Access Compliance Report

Public Rights-of-Way

(Pedestrian Signals)

Intersection ID: N/A	Main Street:	Cross Street: N/A	Location: N/A
ADA ID: 2BF4B7B48869	Signal Type: One Push Button-APS	Overall Compliance: No	Severity Score: BTN 1: N/A BTN 2: N/A No BTN: N/A
Codes/Mitigation Info/Possible Solution		Field Measurements/Component Compliance

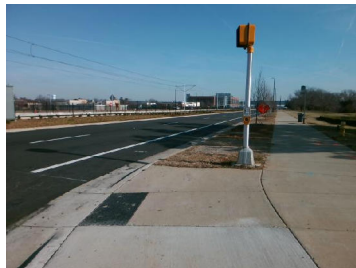
PROW/ADA: R404.2, R404.3, R404.7.3,
R404.7.2, R209.1, MUTCD 4e.10

N/A	B 1 FWD Approach Width (in)	N/A	N/A	B 2 FWD Approach Width (in)	N/A
N/A	B 1 FWD Approach Obstruction?	Yes	N/A	B 2 FWD Approach Obstruction?	N/A
N/A	B 1 FWD Approach Obstruction Dist (in)	4.0	N/A	B 2 FWD Approach ObstructionDist (in)	N/A
N/A	B 1 PARA Approach?	Yes	N/A	B 2 PARA Approach?	N/A
N/A	B 1 PARA Approach Constrained?	Yes	N/A	B 2 PARA Approach Constrained?	N/A
No	B 1 PARA Approach Reach (in)	12.0	N/A	B 2 PARA Approach Reach (in)	N/A
No	B 1 PARA Approach Width (in)	48.0	N/A	B 2 PARA Approach Width (in)	N/A
N/A	B 1 PARA Approach Obstruction?	Yes	N/A	B 2 PARA Approach Obstruction?	N/A
N/A	B 1 PARA Approach Obstruction Dist (in)	4.0	N/A	B 2 PARA Approach ObstructionDist (in)	N/A
No	B 1 Clear Floor Space Slope (%)	3.1	N/A	B 2 Clear Floor Space Slope (%)	N/A
No	B 1 Clear Floor Space XSlope (%)	4.3	N/A	B 2 Clear Floor Space XSlope (%)	N/A
N/A	B 1 PAR Slope (%)	N/A	N/A	B 2 PAR Slope (%)	N/A
Yes	B 1 Height (in)	40.0	N/A	B 2 Height (in)	N/A

Possible Solutions: Remove & Replace
Replace APS Button With New APS Button.
Remove and Replace Clear Space.
